RE: Former Mobil RAS #10MHG/160 14th Street, Oakland, California.

SUBJECT Soil and Groundwater Report Addendum
Former Mobil Service Station 10MHG
160 14th Street, Oakland, California

At the request of ExxonMobil Environmental Services (EMES), on behalf of ExxonMobil Oil Corporation, Cardno prepared this addendum to the *Soil and Groundwater Report*, dated March 28, 2017 (Cardno, 2017). The purpose of this addendum is to provide a cross section of the parking garage to support the existence of a 10-foot thick bio-attenuation zone and to address comments made by the Alameda County Health Care Services Agency, Department of Environmental Health (ACDEH) in a letter dated January 26, 2017, and in electronic correspondence dated July 12, 2017 (Appendix A).

CROSS SECTION A-A'

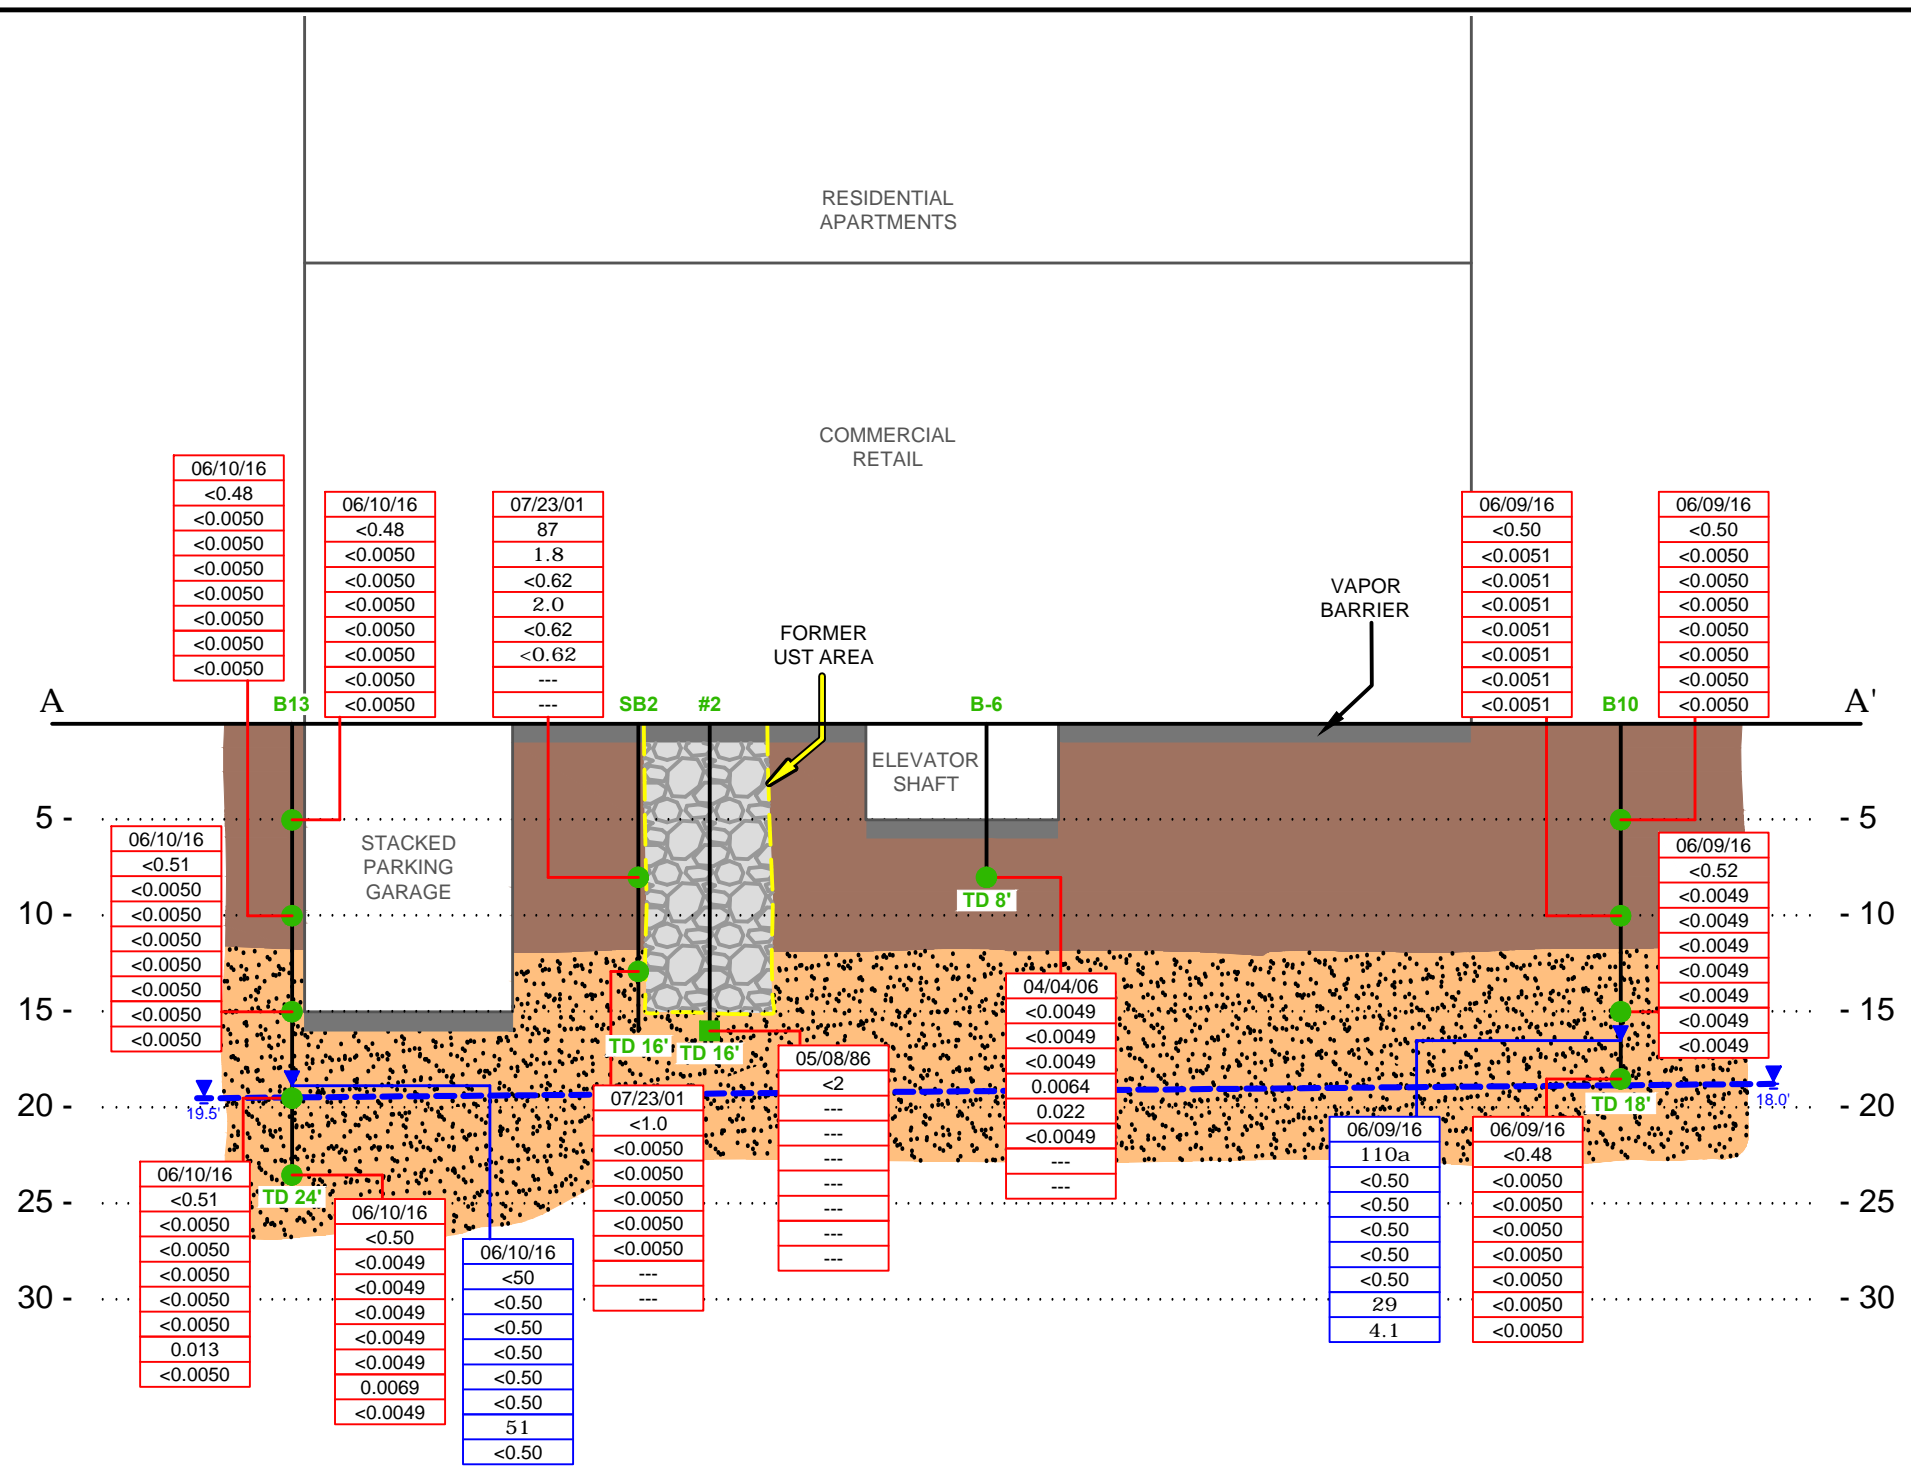
Please prepare a cross section showing the subsurface features, the base of the excavation, and historical soil and groundwater data to support the existence of a 10-foot thick bioattenuation zone. Alternately, if the data does not support the existence of a 10-foot thick bioattenuation zone, please provide documentation that it meets an alternative LTCP scenario or include a work plan to collect sufficient data to determine that it may meet one of the other criteria.

There is at least 10 feet of bio-attenuation zone between the elevator shaft and dissolved-phase benzene concentrations. In addition, "a Stego® Wrap 15-mil Class A vapor barrier was installed prior to the installation of the slab on grade parking garage and the ground floor commercial spaces" (ACC, 2008). A data sheet for the vapor barrier material is included in Appendix C and states that it is used as a sub-slab vapor barrier and can control soil gases. Additionally, "a bentonite waterproofing barrier (Volclay Voltex DS) was installed in the below grade parking garage lift area" (ACC, 2008). Building plans showing slab on grade construction are included in Appendix B. A cross section location map is included as Plate 1. A cross section showing subsurface features is included as Plate 2.
